Permit Application Review

Permit No. 2019-143
Received complete: December 4, 2019

Applicant: Brian Olson; City of Edina
Consultant:
Project: Braemar Salt Storage Building
Location: 7600 Braemar Boulevard: Edina
Rule(s): 4,5
Reviewer: BCO

PLAN AND PROFILE

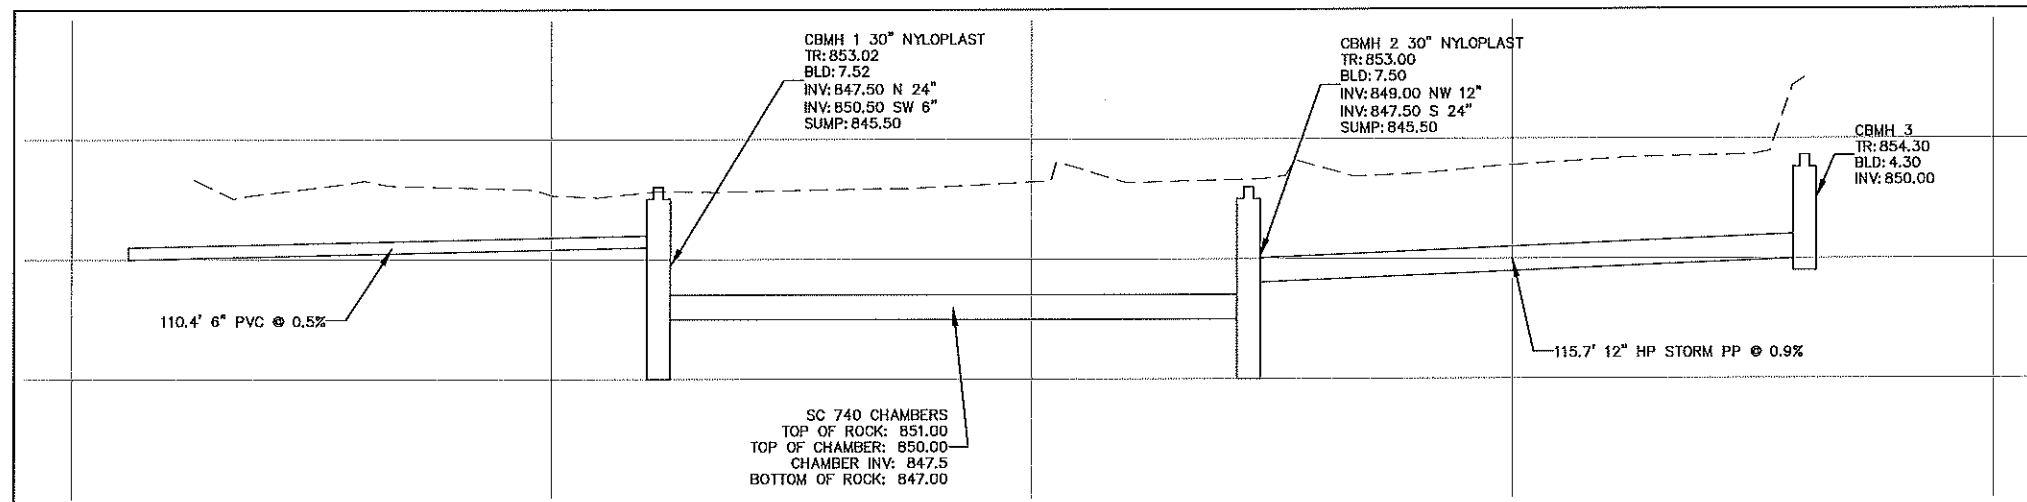
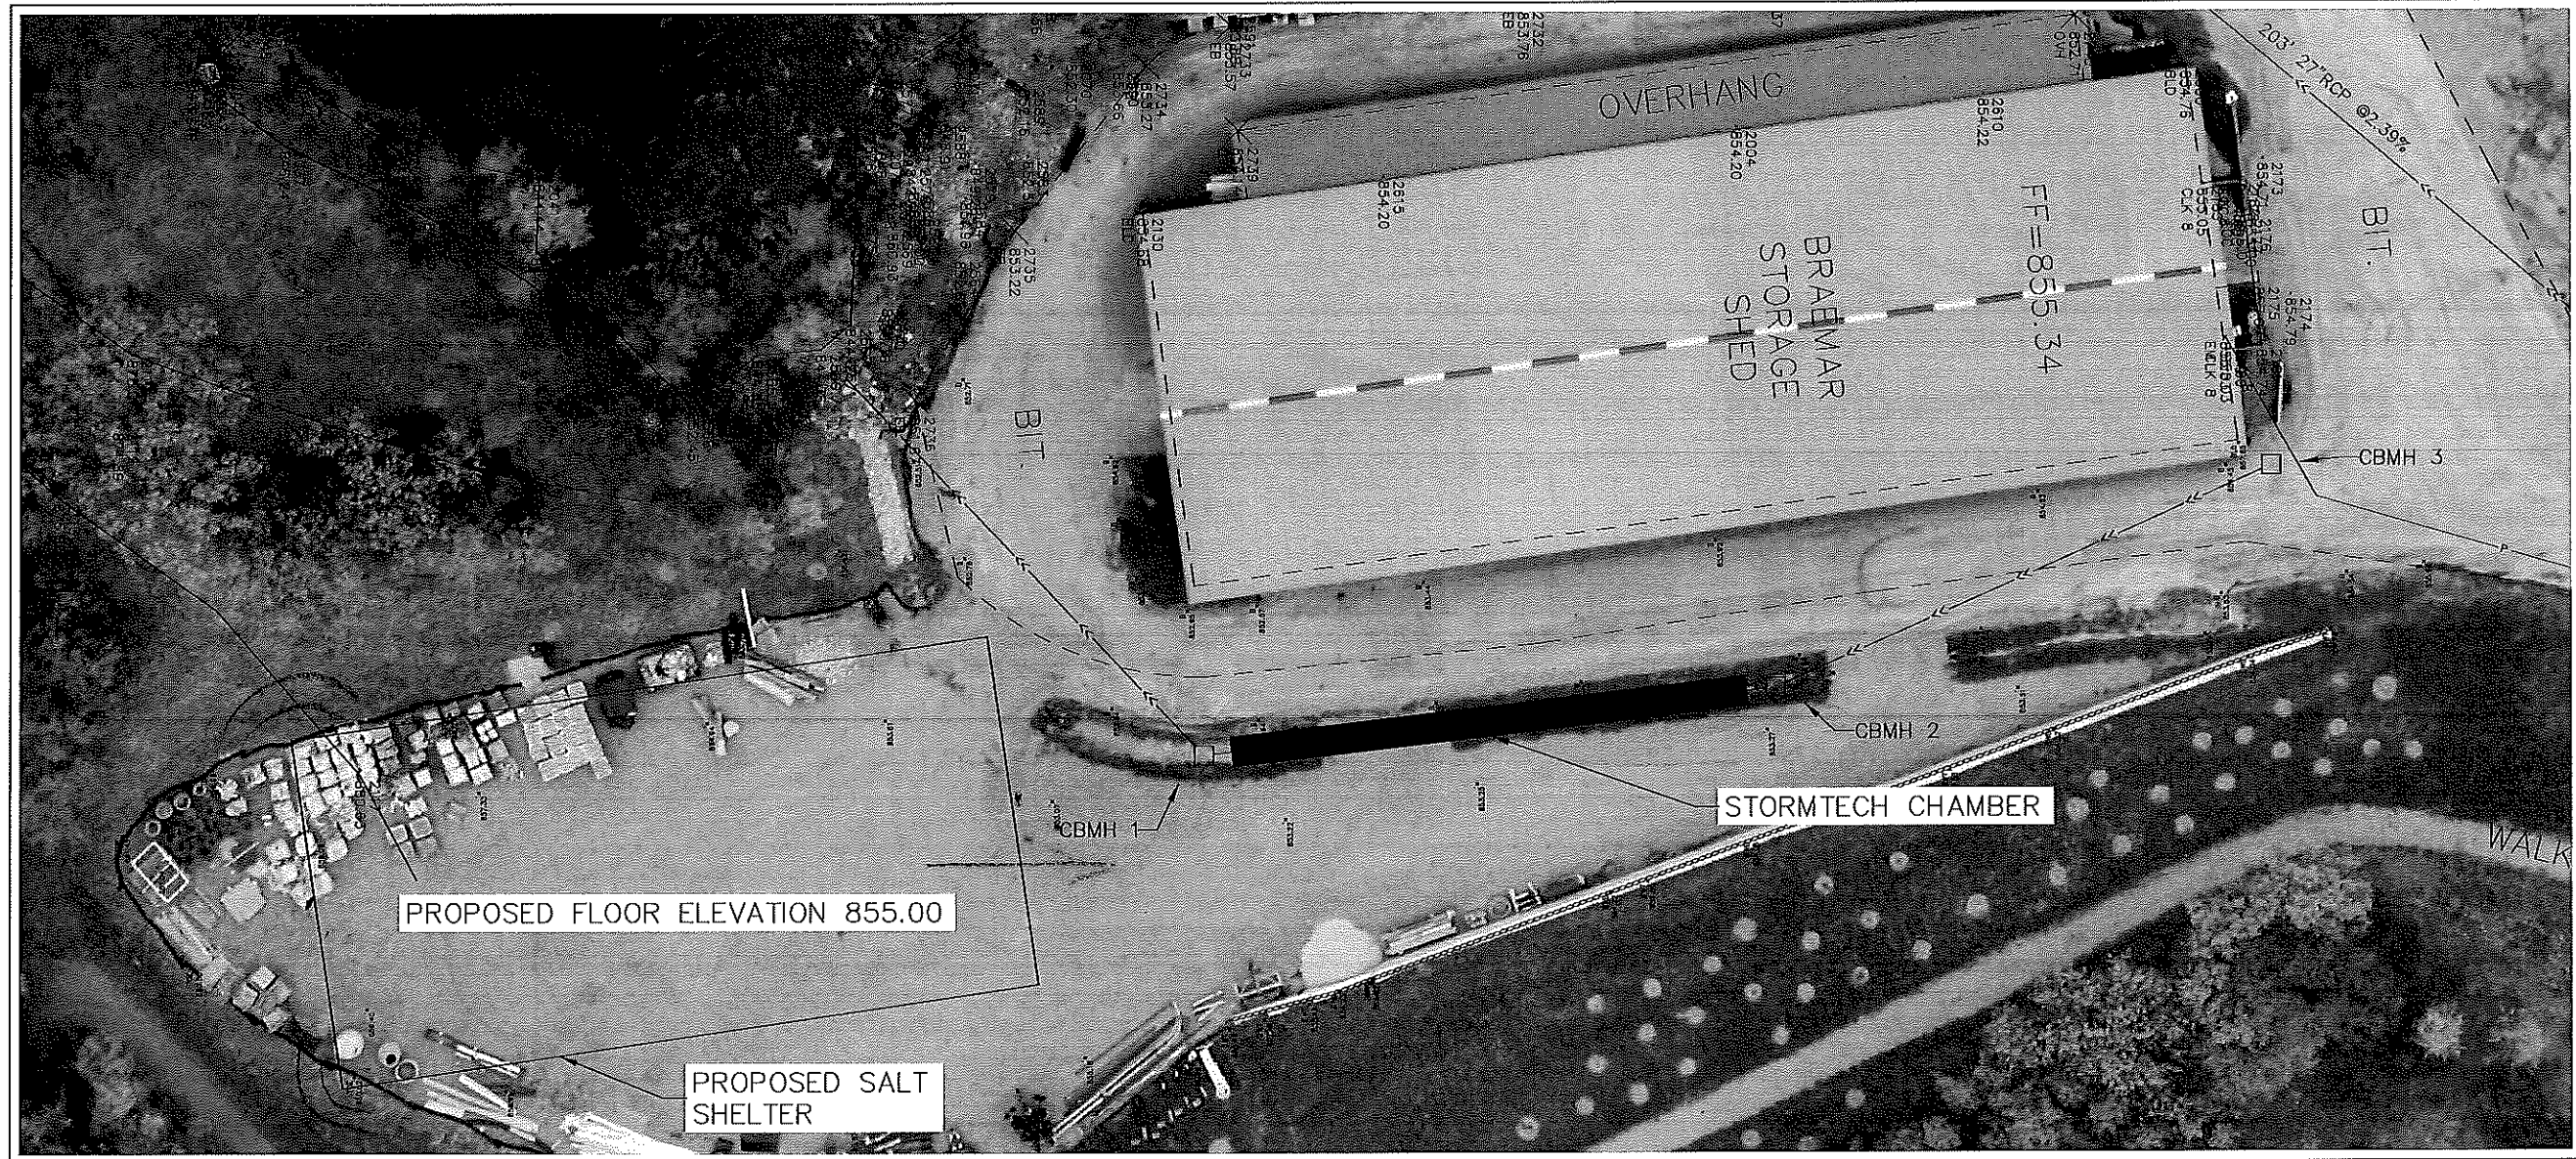
1. General Conditions
2. In accordance with Rule 4.3.5, submission of a document signed by an official with authority with the City of Edina assuming the maintenance obligation for the on-site storm water management facilities.
3. The footprint width for the underground system will require to be increased by 10 feet to accommodate the additional surface runoff from the eastern roof runoff of the Cold Storage Building and the existing eastern surface parking area.
